Campaign Bulletin

File In Section: Product Campaigns
Bulletin No.: 00100A
Date: August, 2001

SUBJECT: 00100A – CONSOLE/ARMREST CAM LATCH COMPLIANCE

**MODELS: 1998-2001 GMC ENVOY
2000-2001 GMC JIMMY DIAMOND EDITION**

Inspection - 1998 Models Only**Important**

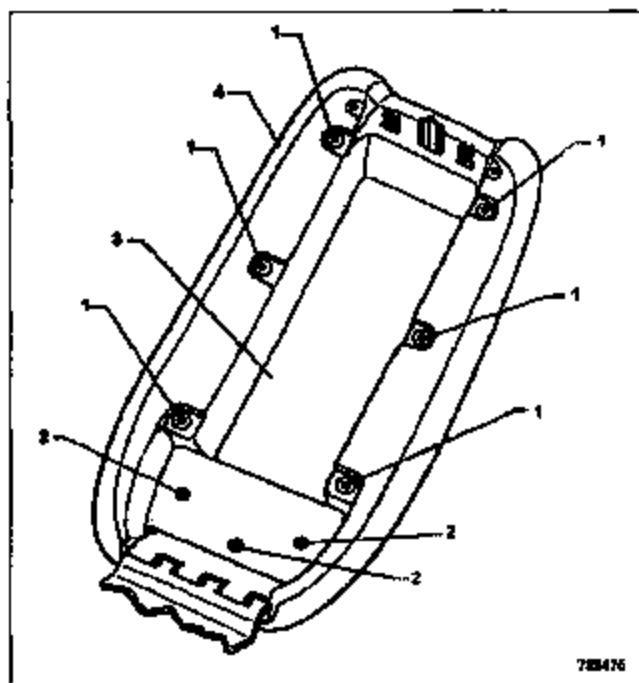
Some early production 1998 vehicles were manufactured with an upper console plate (1) that does not have a round or D-shaped hole (3) located between the two square holes (2). In order to perform this campaign the vehicle **MUST HAVE** this additional hole (3) in the upper console plate.

1. Verify whether or not the vehicle has this additional hole by opening the console compartment cover and comparing the holes in the upper console plate to those shown in the illustration above.
 - If the upper console plate **DOES** have the hole (3) located between the two square holes (2), proceed to the service procedure titled "Inner Console Cover Replacement".
 - If the upper console plate does **NOT** have the hole (3) located between the two square holes (2), proceed to the service procedure titled "Upper Console Plate Replacement".

Upper Console Plate Replacement

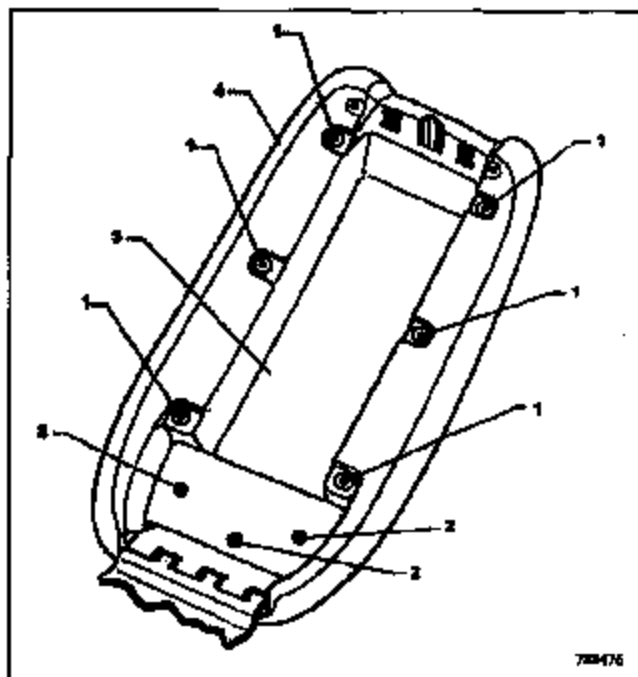
10. Remove and discard the two washer type fasteners that attach the mounting bracket to the console.

11. Remove the CD player and mounting bracket from the console.
12. Release the retaining clips and remove the upper console plate from the lower console.

13. Install the new upper console plate on the lower console.
14. Install the CD player and bracket in the console.
15. Install the two new push on nuts to the CD player bracket and console.

16. Install the four screws that attach the CD player bracket to the console and tighten to 6 Nm (53 lb in).
17. Install the four T-15 torx head screws that attach the CD player cover and tighten to 2 Nm (17 lb in). Reinstall the tape over the two top screws.

SERVICE PROCEDURE

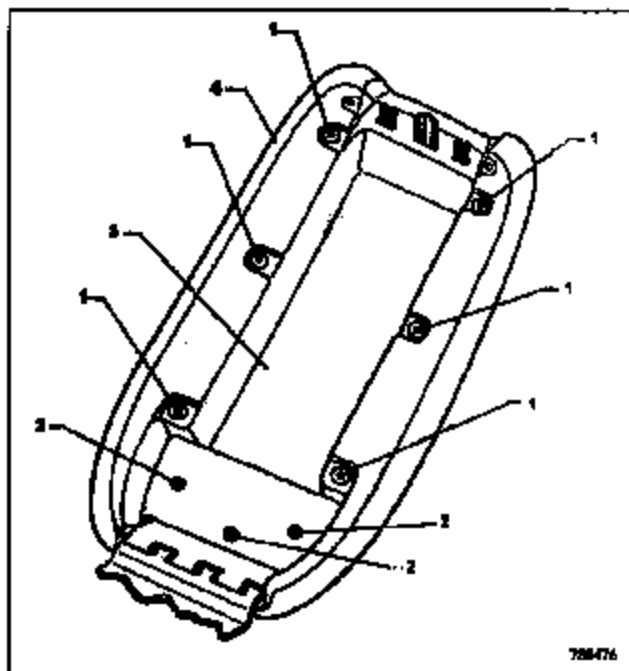
Dealers are to replace the console latch mechanism.

1. Open the floor console cover and remove the six torx head screws (1) and the three phillips head screws (2) that attach the inner console cover to the outer console cover.
2. Separate the inner console cover (3) from the outer cover (4) and discard the inner cover. It is not necessary to remove the console outer cover from the hinge assembly.
3. Install the new inner console cover to the outer console cover.
4. Install the three phillips head screws (2) and then the six torx head screws (1). Tighten all screws to 1.5 Nm (13 lb in).
5. Close the console cover and verify that the latch operates properly.
6. Install the GM Campaign Identification Label.
